Planning & Development Division

File Number	PL 23-186		Contact		Jenn Mose	enn Moses	
Туре	MU-I Planning Review		Planning Commission Date		n Date		November 14, 2023
Deadline	Application Date		October 19, 2023 6		60 Days		December 18, 2023
for Action	Date Extension Letter Mailed		N/A		120 Days		February 16, 2024
Location of Subject		1012 E 2 nd St					
Applicant	St. Luke's Hospital		Contact	Michael Boeselager			
Agent	Erdman Company		Contact	Neil Bright			
Legal Description		See attached	Sign Notice Date		Octo	October 31, 2023	
Site Visit Date		October 31, 2023	Number of Letters Sent		4

Proposal

Applicant is proposing a new skywalk directly above an existing skywalk over 10th Avenue E, connecting St. Luke's Hospital to Building A.

SOUTH ELEVATION

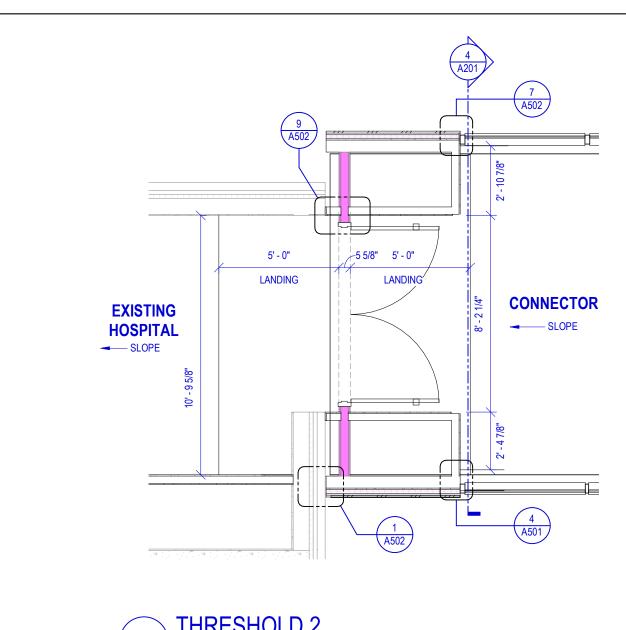
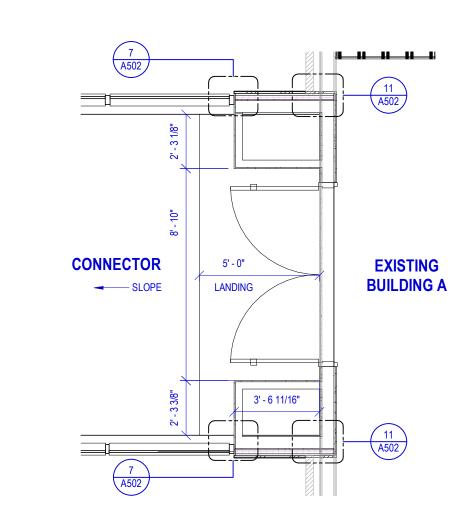
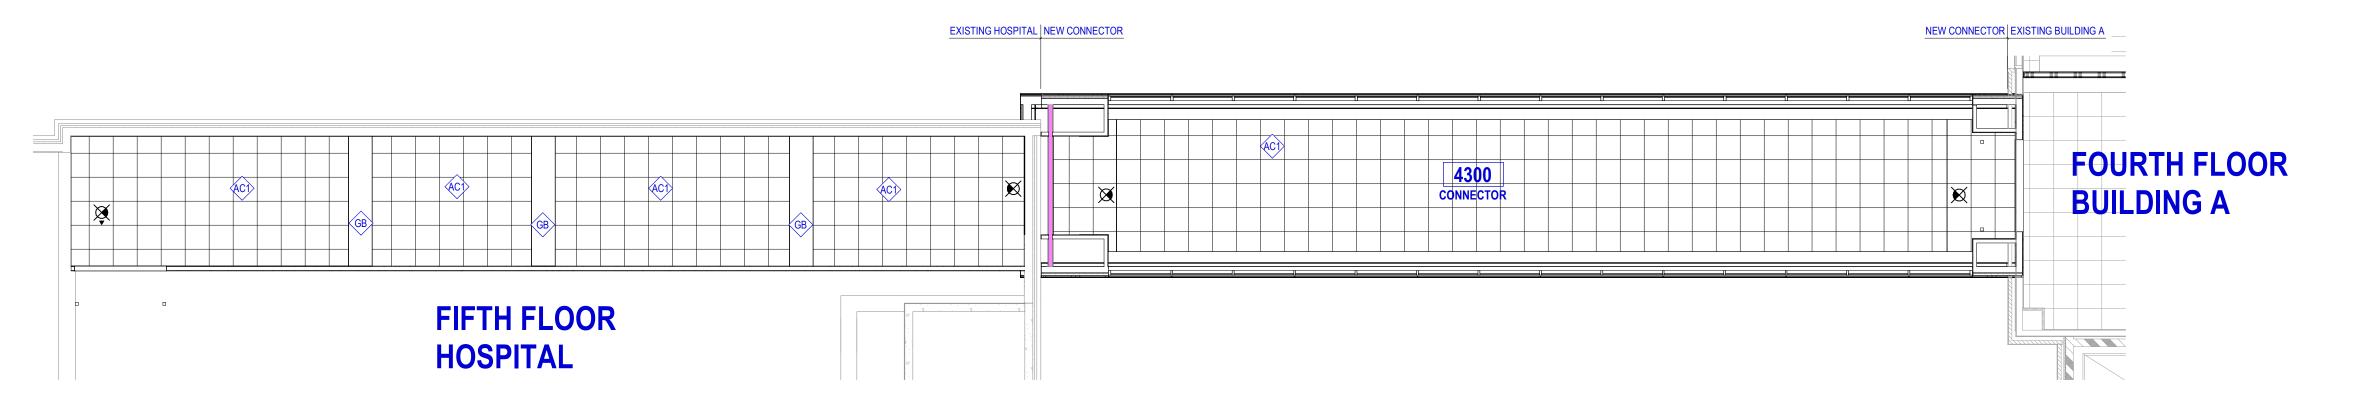
- 2) UDC Section 50-23.6, Skywalks, states that skywalks should not compromise the historic or architectural integrity of existing buildings, shall be approved based on architectural sensitivity and cohesiveness, and that 66% of each vertical side elevation shall be made of glass or transparent materials. The building elevations and 3D rendering submitted with the application show that this skywalk is designed with window openings that vertically line up with the skywalk directly below. Structural elements and exterior materials will blend with the connector below, giving these skywalk connections a unified feel within the hospital campus. Each window opening is approximately 50 square feet, for a total of 700 square feet per side. With the addition of spandrel glass, the skywalk provides 54% transparency. According to the applicant, "We would consider 66% infeasible due to the fact this connector will help bridge 4' of vertical difference between the floors on the two buildings leading to a sloped floor and structure. We also are attempting to avoid roof penetrations in the form of roof drains which require maintenance and create leak points so the roof is sloped as well which also means the structure is sloped. With the sloped floor along with a sloped roof structure, we are limited in our ability to provide 66% transparency but will provide the minimum 50% or more as we continue to refine our design."

- 1. The project be constructed, limited to, and maintained according to the plans and building elevations submitted with this application.
- 2. The Planning Review shall only be effective upon approval and issuance of a Concurrent Use Permit for the placement of the structure in the right-of-way.
- 3. Any alterations to the approved plans that do not alter major elements of the plan may be approved by the Land Use Supervisor without further Planning Commission approval; however, no such administrative approval shall constitute a variance from the provisions of Chapter 50.
